DESCRIPTIVE REPORT

Descriptive Report to Accompany Hydrographic Survey H11008

Project OPR-P139-RA-02
Southwest Prince William Sound, Alaska

Revisions Compiled During Office processing and Certification.

Figure 2. H11008 Junction Surveys

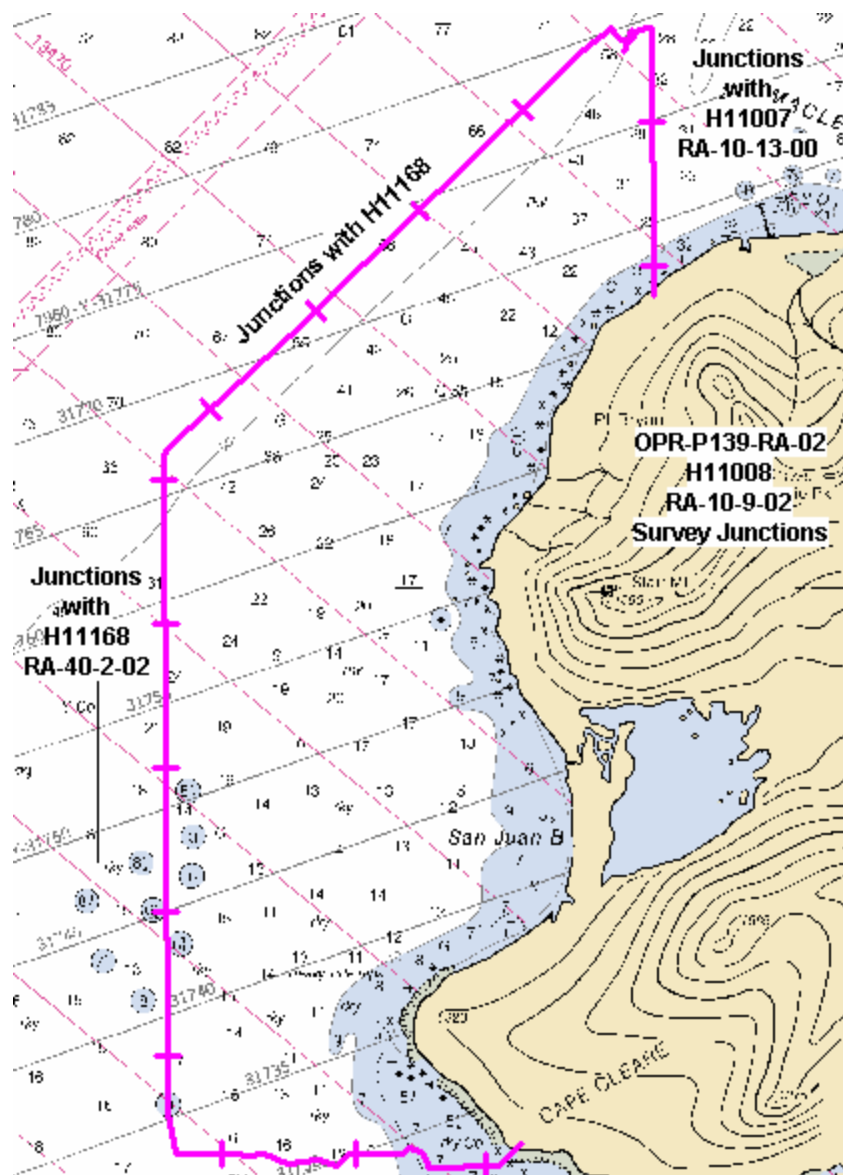
Surveys H11168 and H11007 junction well with this survey, with differences of one to two fathoms.⁶

Final comparisons will be made at the Pacific Hydrographic Branch (PHB) after the application of smooth tides.⁷

⁵ The junction with survey H11168 and H11007 are complete. A "Joins" note has been added to the smooth sheets where applicable.

⁶ Concur

⁷ Concur, results of the comparison after applications of approved tides are considered good.
